CHAIN VALLEY COLLIERY
Built Features Management Plan
S4 Miniwall Panel
ENVIRONMENTAL MANAGEMENT PLAN

Reviewers	Katie Weekes EMM Consulting Pty Ltd
	Chris Armit EMM Consulting Pty Ltd
Authorised by:	Chris Armit
	Environment & Community Coordinator
	Delta Coal
Date:	12 May 2020

A copy of the S4 Built Features Management Plan was emailed to the below regulators and stakeholders on 20 November 2019. A summary of the comments received during this round of review, and amendments subsequently made to the document prior to finalisation are detailed in **Table 2**. Evidence of consultation is provided in **Appendix 1**.

Figure 6: S2, S3 and S4 Miniwall (MWS2, MWS3 and MWS4) Protection Barriers and Wallarah seam workings location (Strata2, 2019)

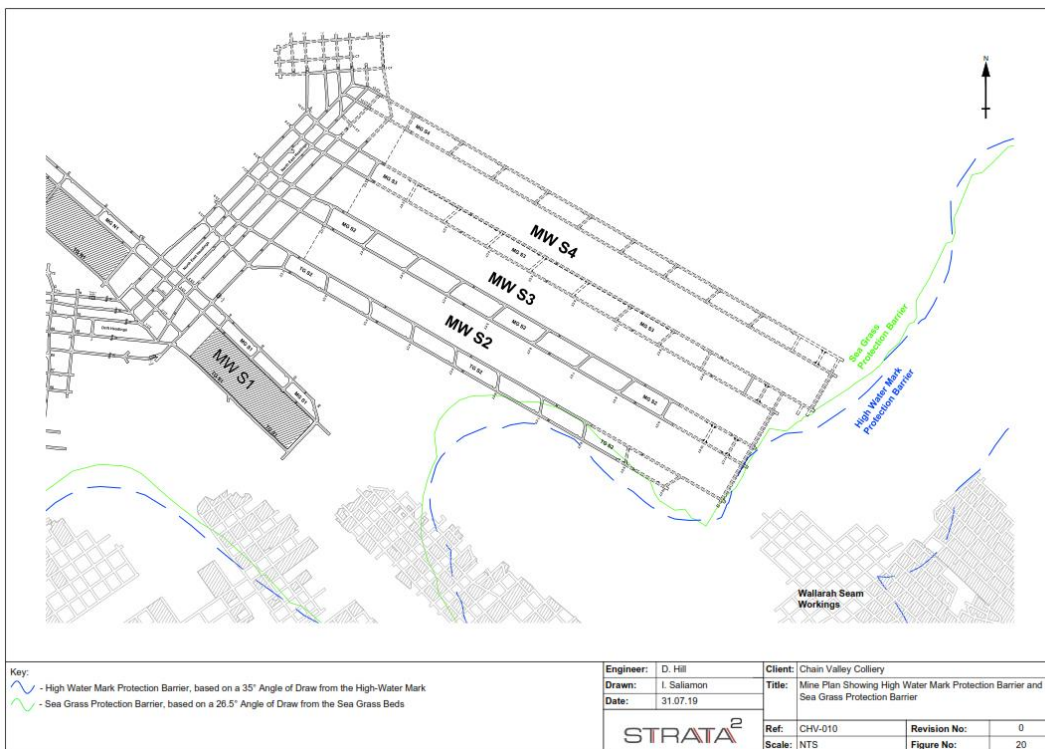
The only comment I would make is that as houses & moorings along the shoreline have been identified and the critical control for these is mine layout and associated predicted angle of draw it would be beneficial to include the Wallarah Seam workings (refer in Fig 5 of the BFMP). It has been discussed at length in the past that the overlying workings have the potential to create subsidence outside the angle of draw.

Thanks for your feedback Ray, appreciate it.
I'll get Tim to include the Wallarah workings in the BFMP figure.
The S4 EP will also include Dave Hill's subsidence prediction report.
Cheers,
Chris
